Petition No. 1312
Candlewood Solar LLC
197 Candlewood Mountain Road
New Milford, CT
Interrogatories

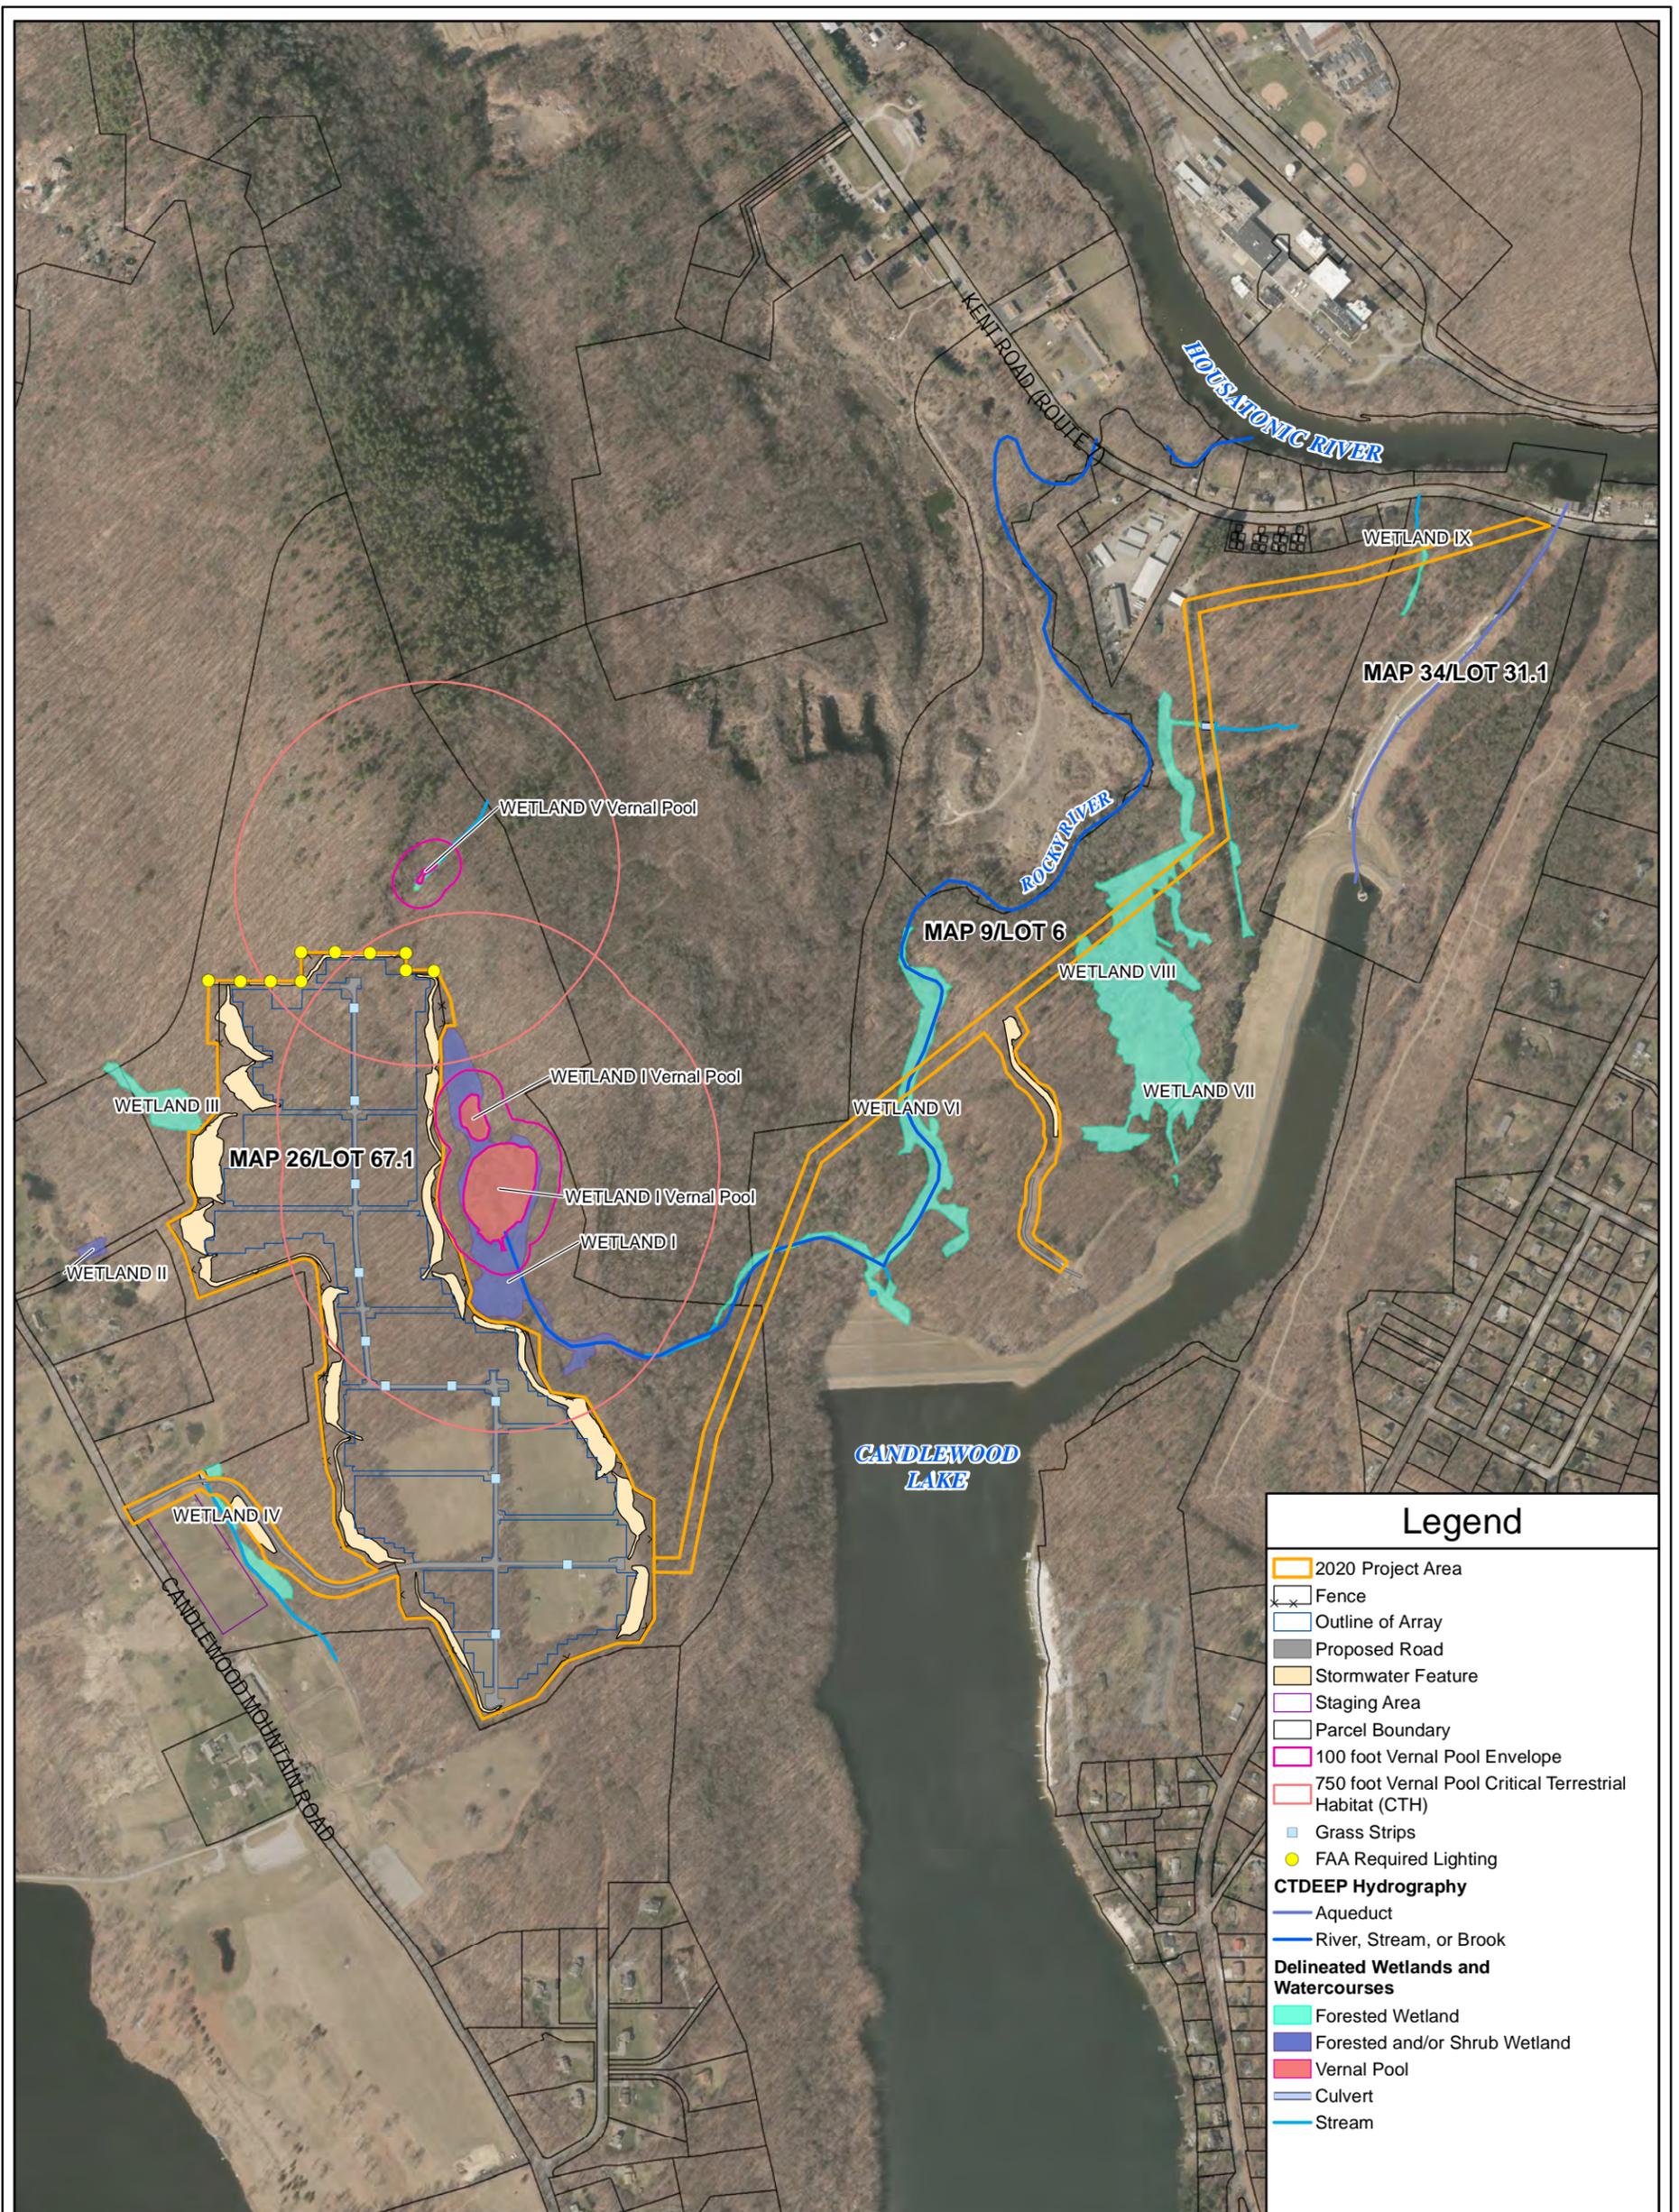
- Provide the current status of the Federal Aviation Administration (FAA) Determinations of No Hazard to Air Navigation. Would CS need to seek any extensions or refile with the FAA for revised determinations?

Section i of Council's April 25, 2019 Staff Report notes, "...CS will install approximately 14 each L-810 LED TRO series red obstruction lights per those spacing requirements along the top of the fence in response to the FAA evaluation." As noted above, a total of 10 lighting fixtures are proposed (see Figure 2).

Response: Candlewood Solar has filed for and obtained extensions to the Federal Aviation Administration ("FAA") Determinations of No Hazard to Air Navigation ("Extensions"). The Extensions were issued on October 25, 2019 (see Attachment A). The Extensions became final on December 4, 2019. The Extensions extend the effective period of the Determinations to April 25, 2021 unless otherwise extended, revised, or terminated by the FAA. All conditions identified in the original Determinations still apply. The three (3) FAA

The marking/lighting condition requires the structure "to be marked/lighted in accordance with FAA Advisory circular 70/7460-1 L Change 1, Obstruction Marking and Lighting, red lights – Chapters 4,5(Red),&12." Attachment A contains a copy of FAA Advisory circular 70/7460-1 L Change 1 ("FAA Advisory circular"). It should be noted that, "If the structure/bridge/extensive obstruction exceeds 150 feet (46 m) horizontally, at least one steady-burning light should be displayed for each 150 feet (46 m), or fraction thereof, of the overall length of the major axis.." (See FAA Advisory circular, Section 5.8.2 Prominent Buildings, Bridges, and Similar Extensive Obstructions.) As such, while the FAA Determinations are associated with 3 points, the northern extent of the array requires obstruction marking/lighting. The lighting fixtures will be mounted on the perimeter fence surrounding the array and will be mounted roughly 10 feet above grade. A total of ten (10) lighting fixtures are proposed. Figure 2 shows the approximate locations of the FAA obstruction lighting that will be installed on the perimeter fence. In accordance with FAA requirements, the lights will be steady burning red lights. The lights will be operated by a photocell and will be activated when the ambient light falls below a specific level.

Figure 3.

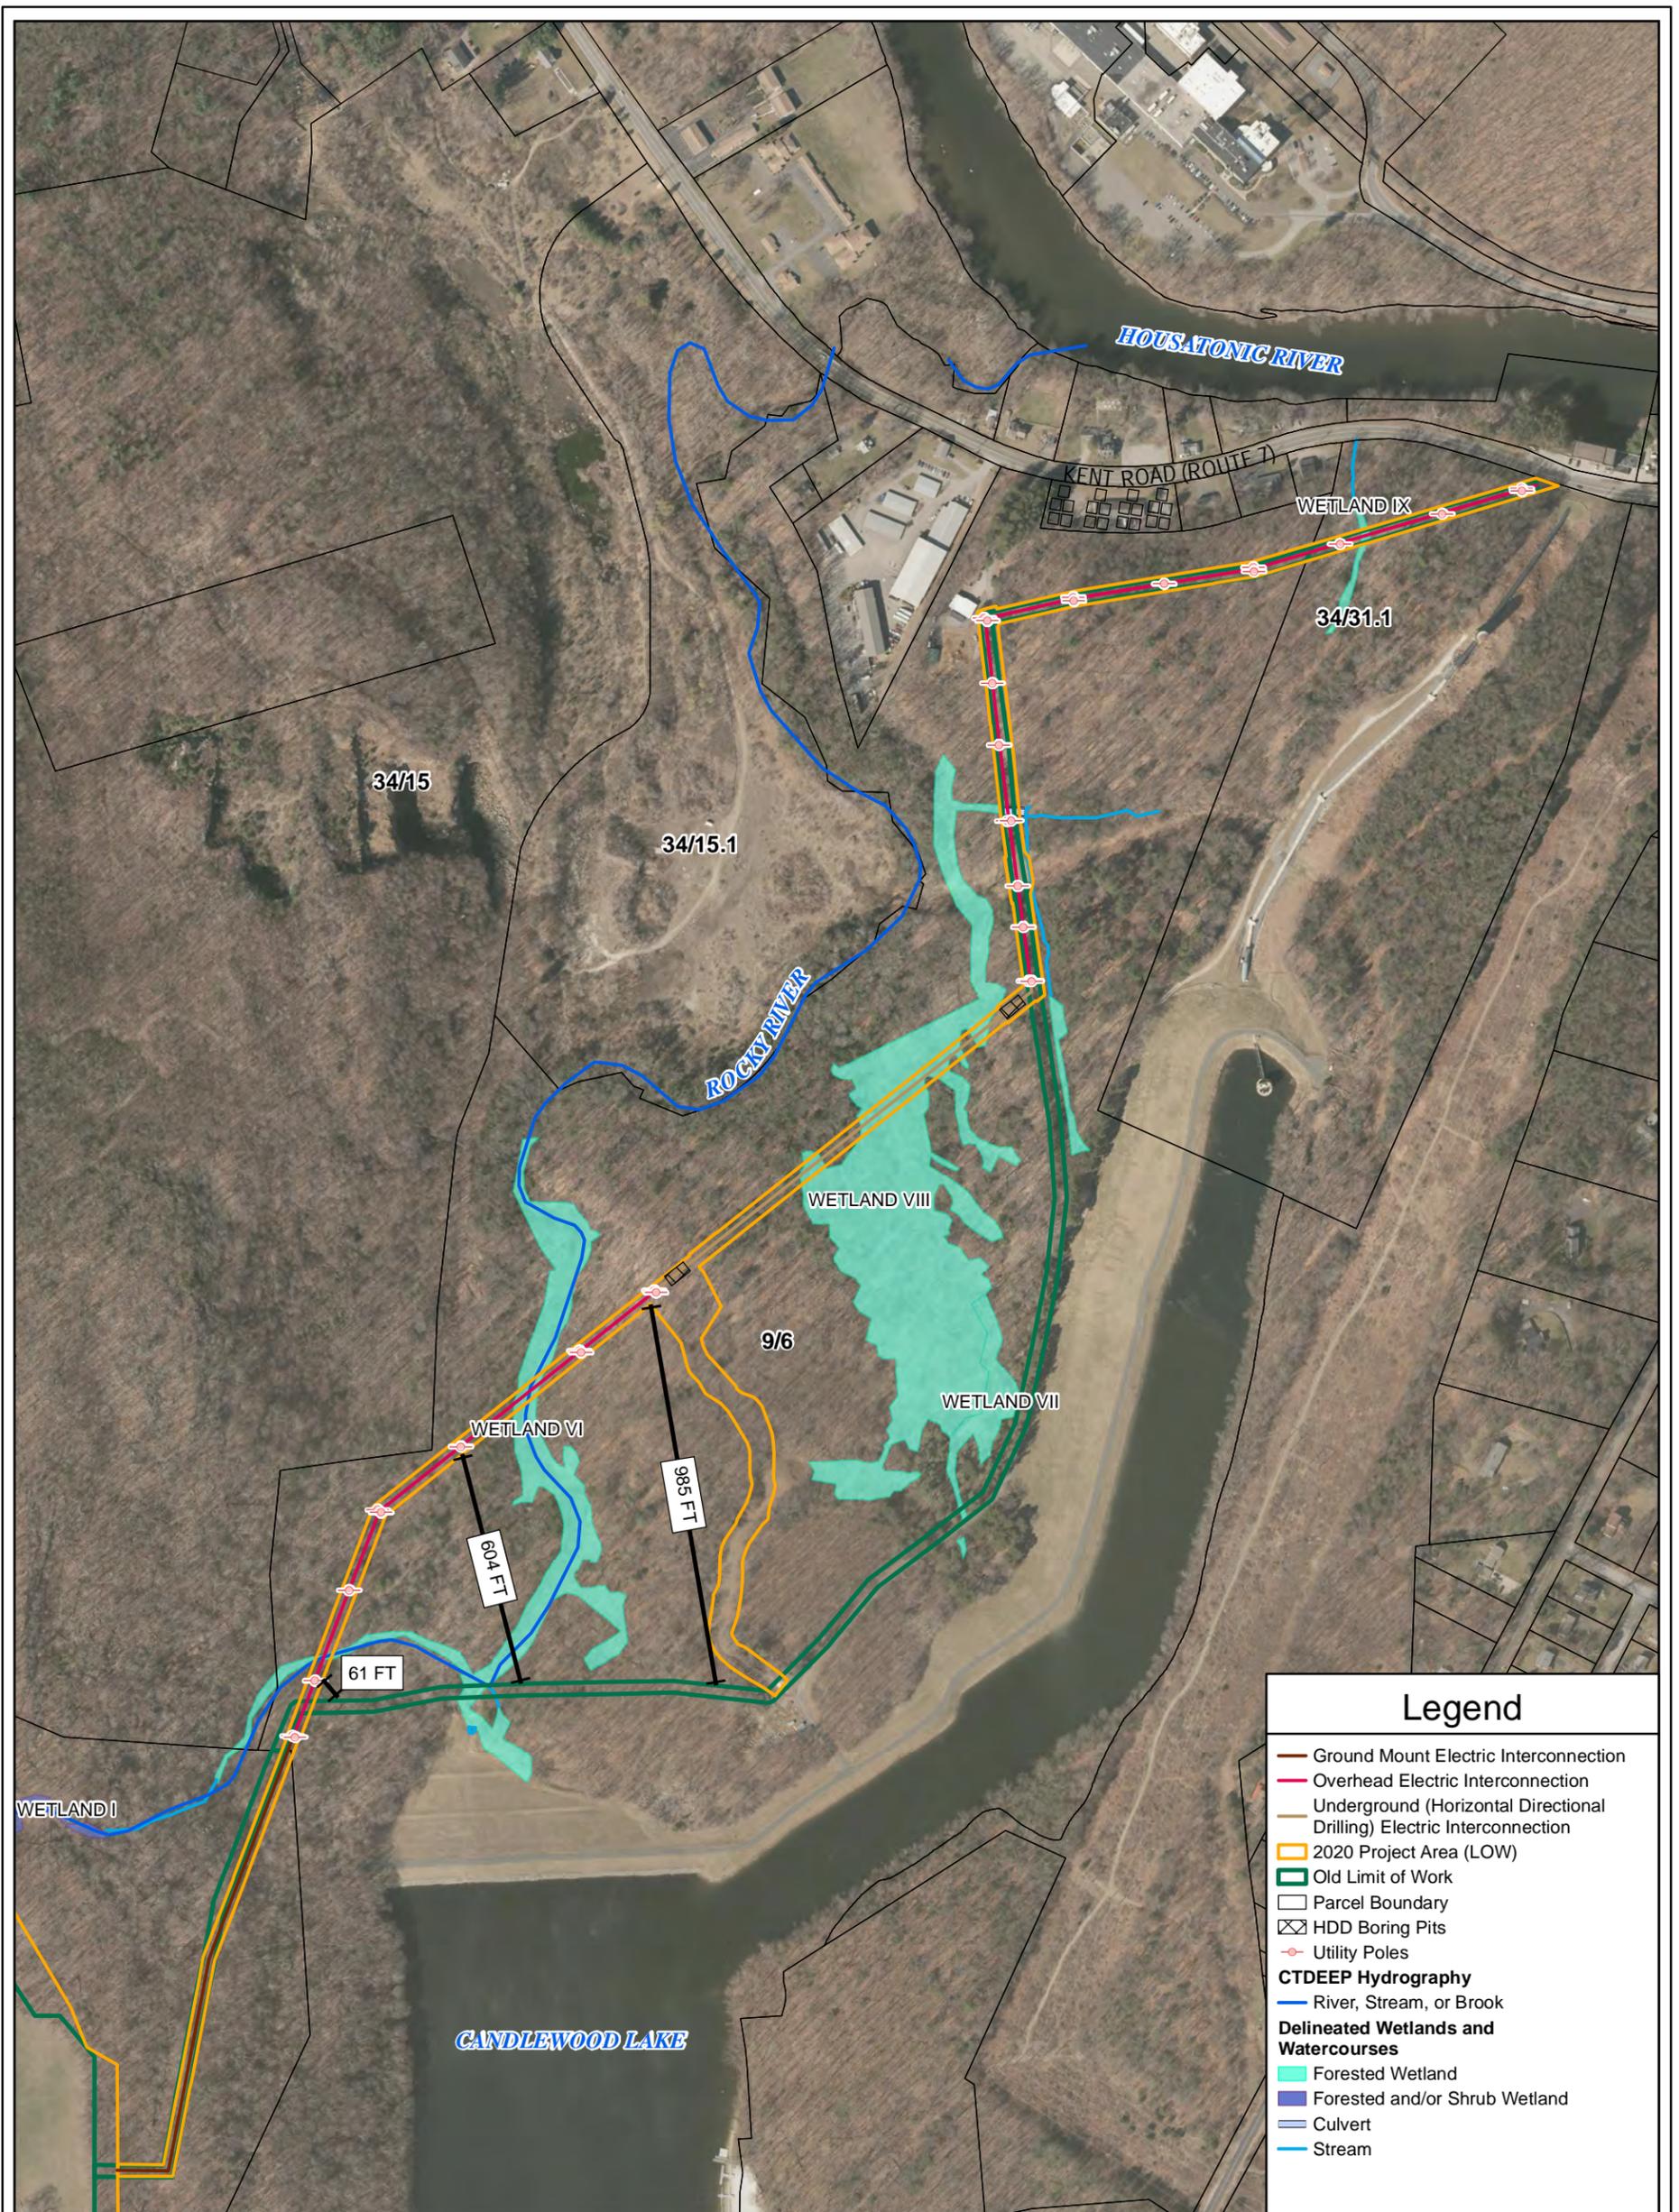
8. Would the proposed changes to the electrical interconnection in the D&M Plan Revisions affect the visibility of the electrical interconnection from Candlewood Lake or Lynn Deming Park? Explain.

In order to minimize impacts along the entire length of the electric interconnection corridor, three different engineering methods (ground mount, overhead, and horizontal directional drill ["HDD"]) will be employed (see Figure 3). Specifically, the electric interconnection corridor will be constructed as follows:

As such, the only modification to the electrical interconnection that could potentially affect the visibility of the electrical interconnection from Candlewood Lake or Lynn Deming Park are associated with the revised overhead segment from the Rocky River to first HDD boring pit (approximately 1,550 feet).

The majority of the overhead segment from the Rocky River to first HDD boring pit is located further north than the approved route included in the 2019 D&M Plan by approximately 61 – 985 feet (see Figure 3). Table 2.9-1 of the Environmental Assessment dated June 2017 notes that Lynn Deming Park is approximately 720 feet southeast of the interconnection route. Based on the revised electric interconnection corridor layout, the overhead segment from the Rocky River to first HDD boring pit is located approximately 1,575-2,224 feet from Lynn Deming Park (see Figure 4). A total of seven (7) poles will be installed along this overhead segment (see Figure 4). The poles will range from approximately 43 feet to 61 feet 2-inches tall as compared to 45-55 feet tall (2017 Interrogatory) and 38-feet 8-inches to about 61 feet 2-inches (2019 staff report) depending on local topography variation (see Attachment C).
